ADDENDUM TRANSMITTAL

ADDENDUM TO THE CONTRACT DOCUMENTS	Page Number	No. of Pages
Addendum No. Two (2)	Date Addendum Issued: May 24, 2024	
Issuing Office Alaska State Parks, Design & Construction Section 550 W. 7 th Ave., Suite 1340, Anchorage, Alaska 99501 Phone: 269-8731 Fax: 269-8907	Previous Addenda Issued One (1)	
Project: Old Kasilof Landing SRS Site Development Project No.: 73032-1	Date and Hour of Quotes Due June 5th, 2024 at 2:00 PM prevailing time

SPECIAL PROVISIONS Old Kasilof Landing SRS Site Development Project Number 73032-1

STEEL STAIR

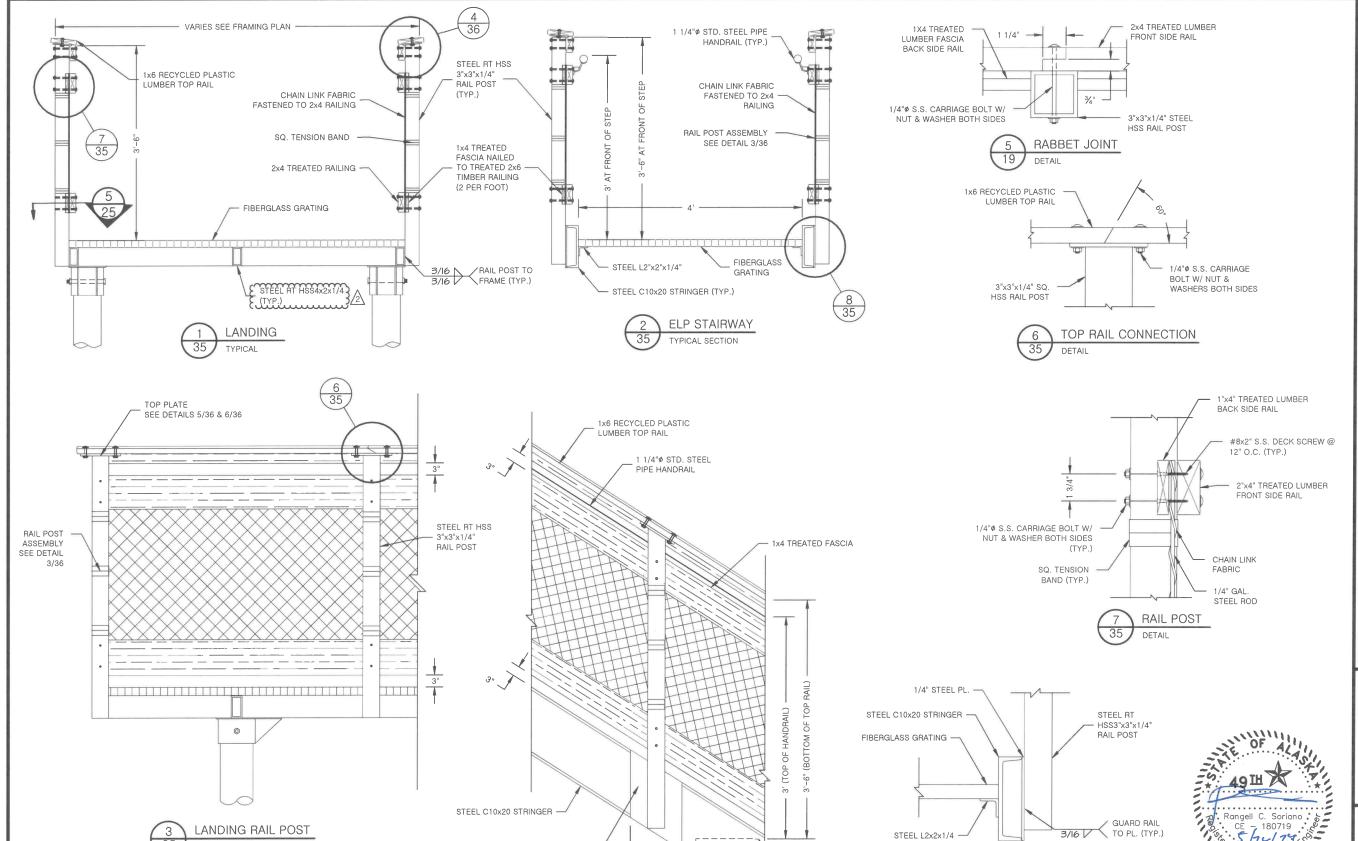
CORRECTED DIMENSIONS
